STAFF REPORT
KETCHUM PLANNING AND ZONING COMMISSION
REGULAR MEETING ON FEBRUARY 28, 2023

- PROJECT: McGavick Residence
- FILE NUMBER: P22-048A
- APPLICATION: Mountain Overlay Design Review (Final)
- PROPERTY OWNER: The Dirty Foot Gang LLC
- REPRESENTATIVE: Jim McLaughlin, McLaughlin and Associates (Architect)

- LOCATION: 307 Garnet Street (ESMERALDA SOUTH SUBD LOT 2 BLK 1)
- ZONING: Limited Residential (LR)
- OVERLAY: Mountain Overlay
- REVIEWER: Morgan Landers, AICP - Senior Planner

**OVERALL SITE
DISTURBANCE
AND
REVEGETATION
PLAN**

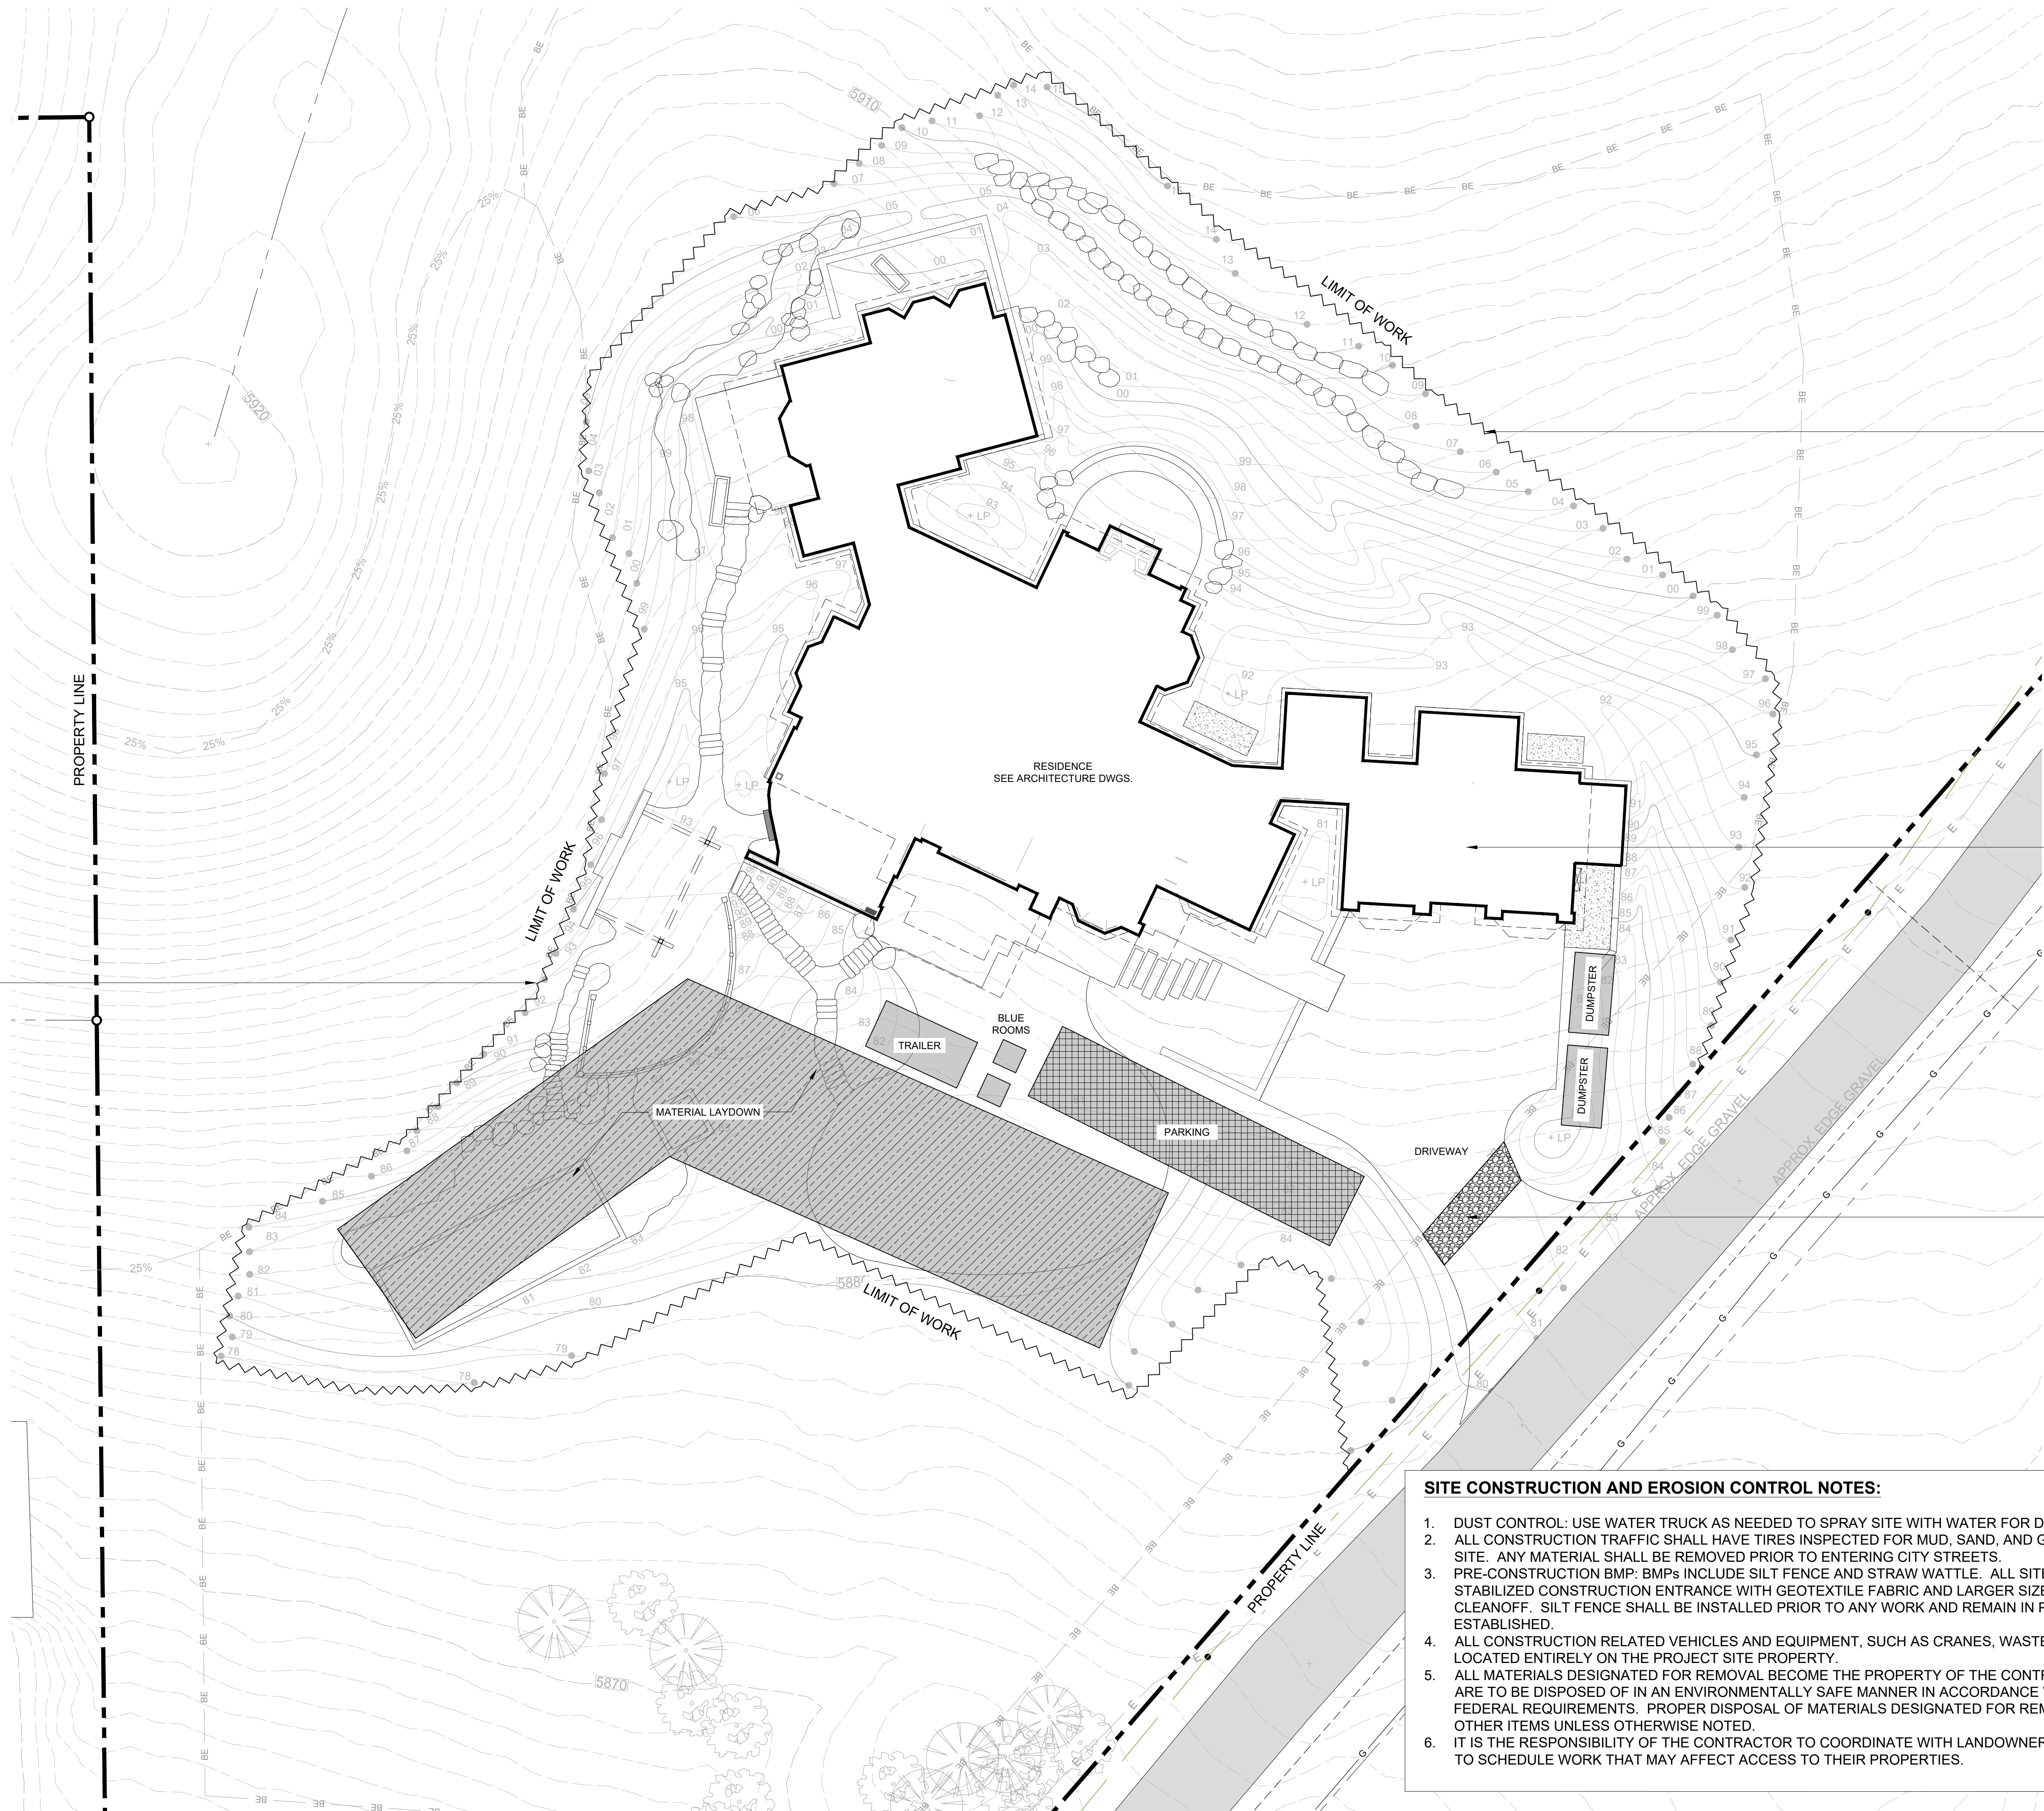
KMC Section 17.104.070A.9 states that “Cuts and fills allowed for roadways shall be minimized; lengths of driveways allowed shall be minimized; all cuts and fills shall be concealed with landscaping, revegetation and/or natural stone materials. Revegetation on hillsides with a clear zone of thirty feet (30’) around all structures is recommended. Said clear zone shall include low combustible irrigated vegetation with appropriate species, on file with the Ketchum planning department. Revegetation outside of this clear zone should be harmonious with the surrounding hillsides.” This standard is primarily focused on prevention of structure damage in the event of a wildfire; however, the last sentence is of specific note related to the type of vegetation that should be outside the clear zone. As shown on Sheet L4.01, the proposed project is meeting minimum fire code requirements of a 10-foot clear zone. The fire department has reviewed the proposed planting plan and does not believe an additional 20 feet of clear zone should be required for the project.

Related to revegetation of the property outside the clear zone, the preapplication included significant landscaping that was of a formal nature and did not blend with the surrounding hillsides, which is primarily sage brush, tall grasses and other drought tolerant species. The applicant has revised the landscape plan to better match the surrounding hillsides as shown on page 2 of Attachment C and Sheets L-101 and L-4.00 of Attachment B. Staff believes the changes to the landscape plan are very positive but has concerns about the play lawn. The lawn is proposed to be a fescue turf grass that is drought tolerant. Other than landscaping down the hill in the more developed area of Garnet Street, turf grasses are not found within the surrounding hillsides.

Upper Level Floor Plan / Exterior Lighting Plan
1/8" = 1'-0"

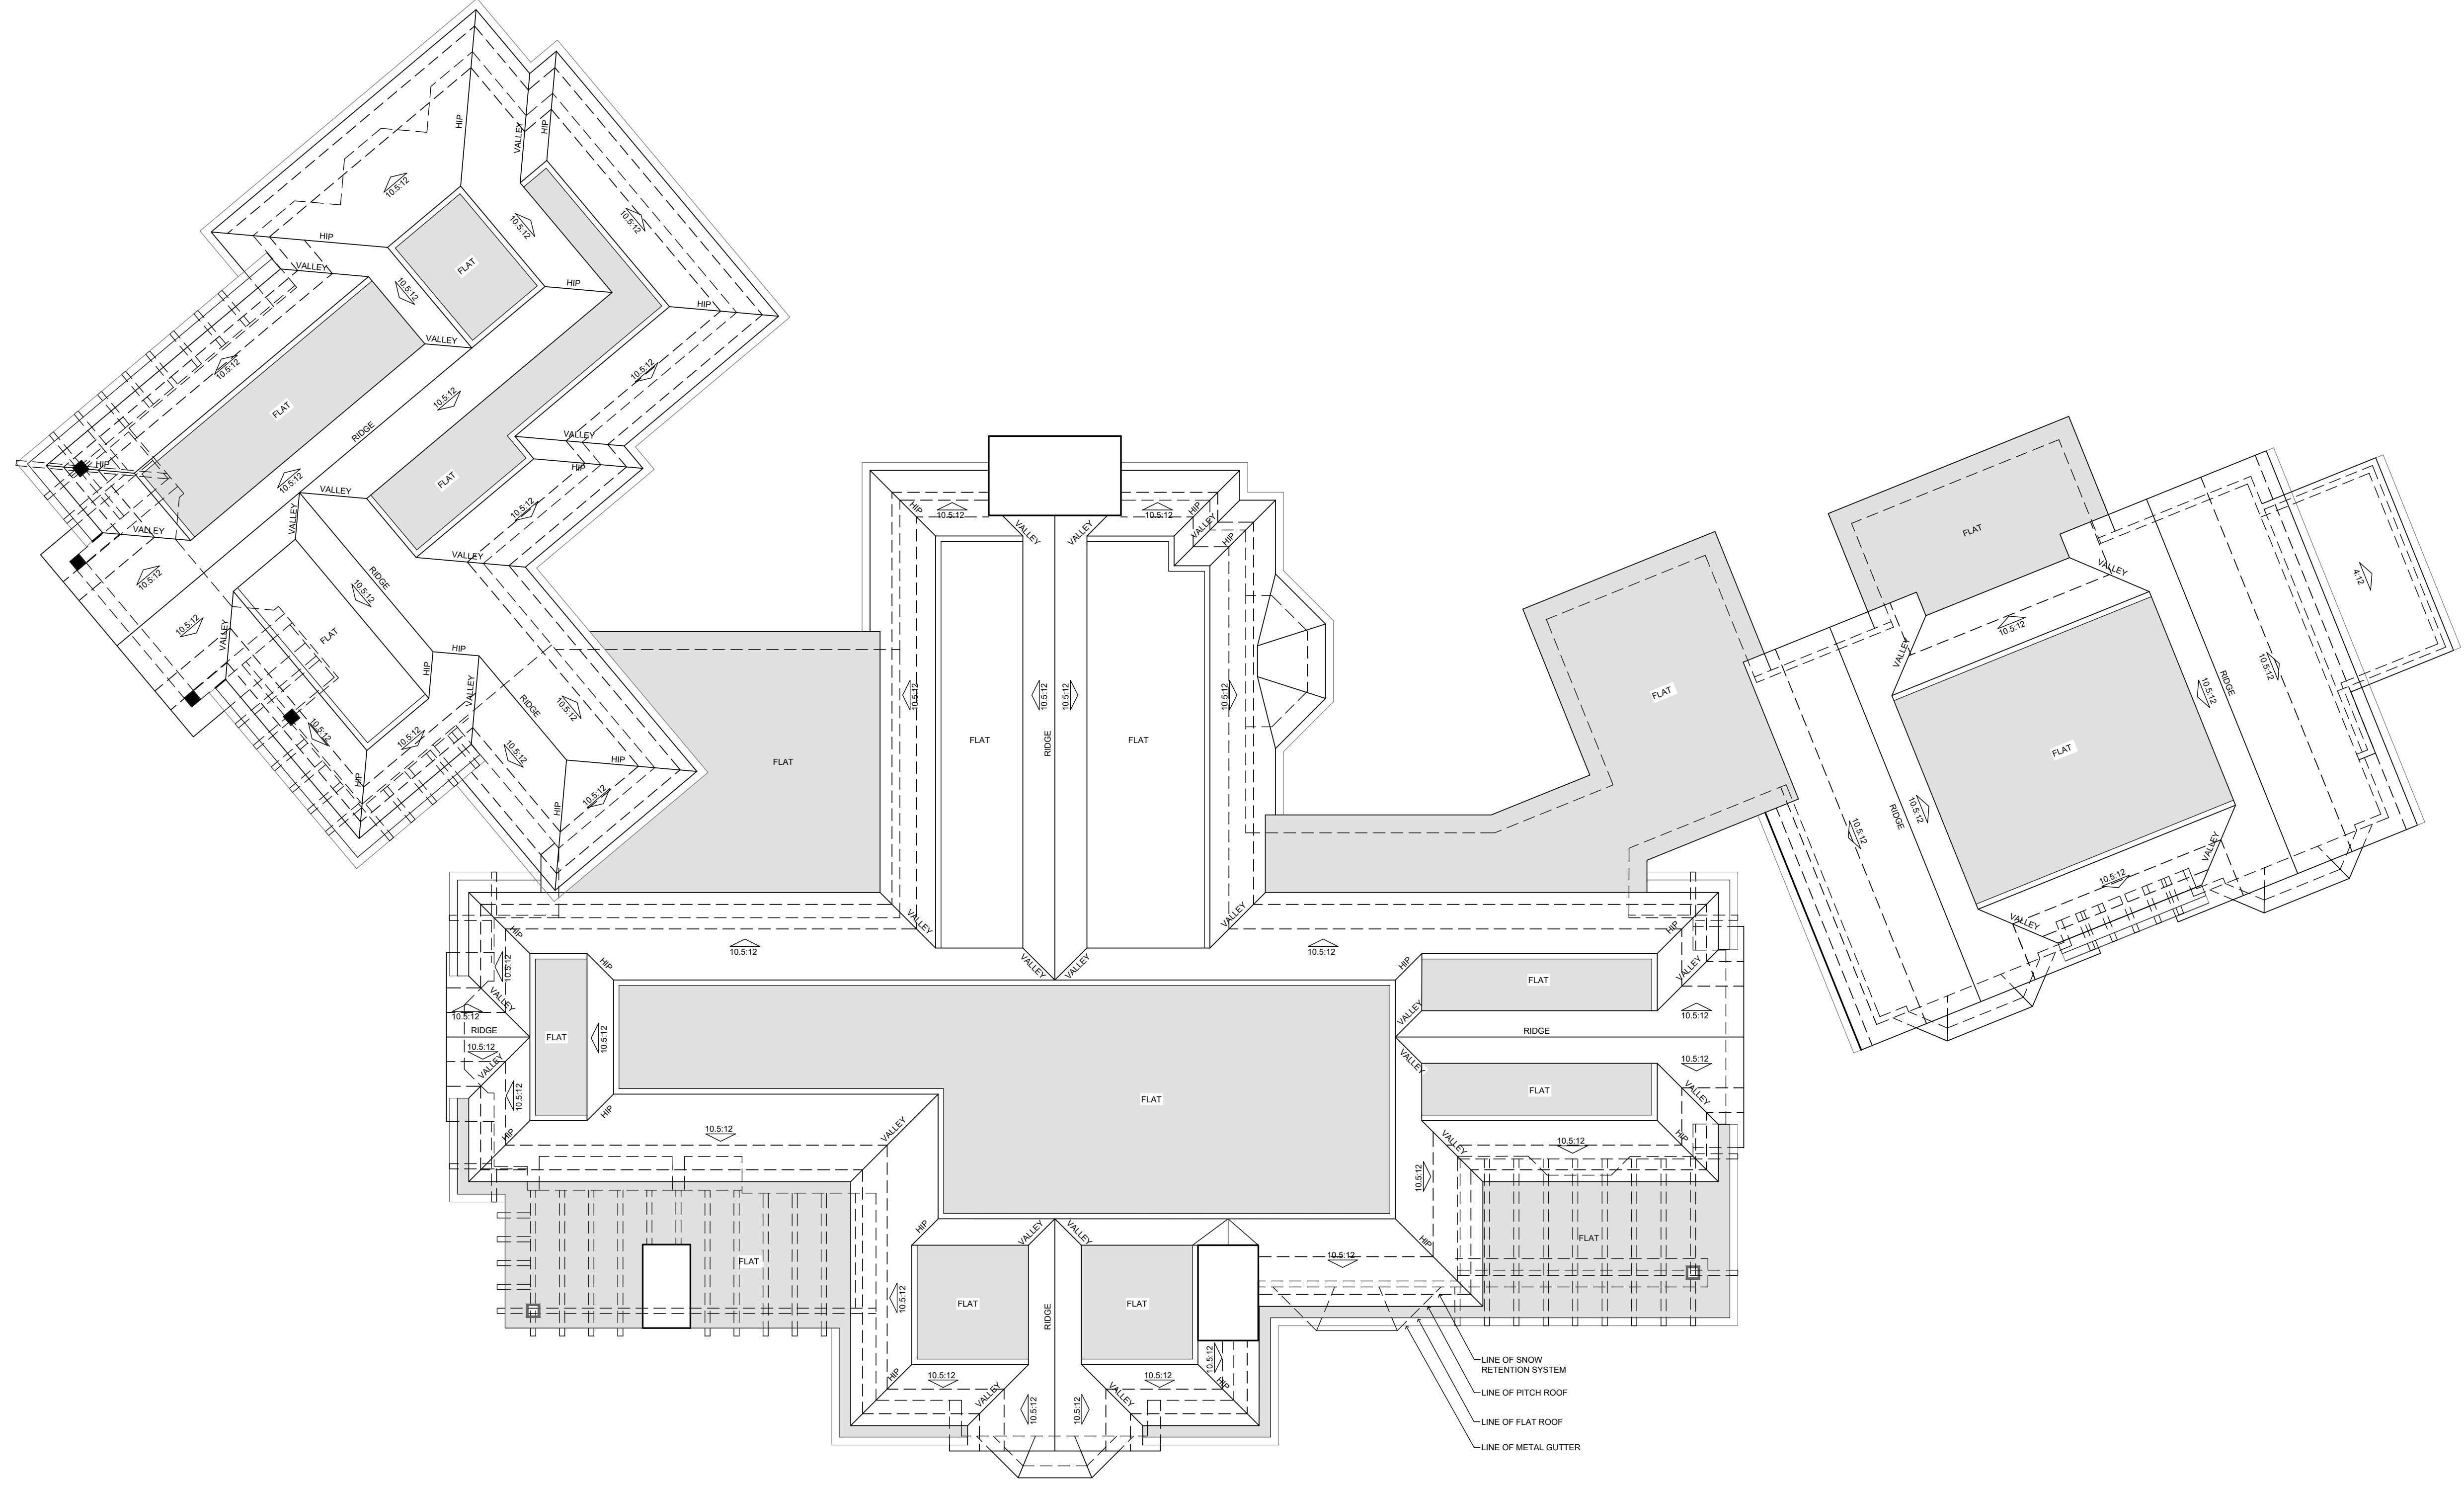
Sheets A1 and A2 of Attachment B show the building footprints of the residence proposed at preapplication in blue and the current footprints proposed in black, with summary tables for each to illustrate proposed changes. The most significant change of note is the reduction in size of the garage wing and the reduction of habitable square footage on the lower level under the main wing and the master wing. Overall, the building coverage for the project, as demonstrated by the upper-level footprint, has been reduced by approximately 1,800 SF.
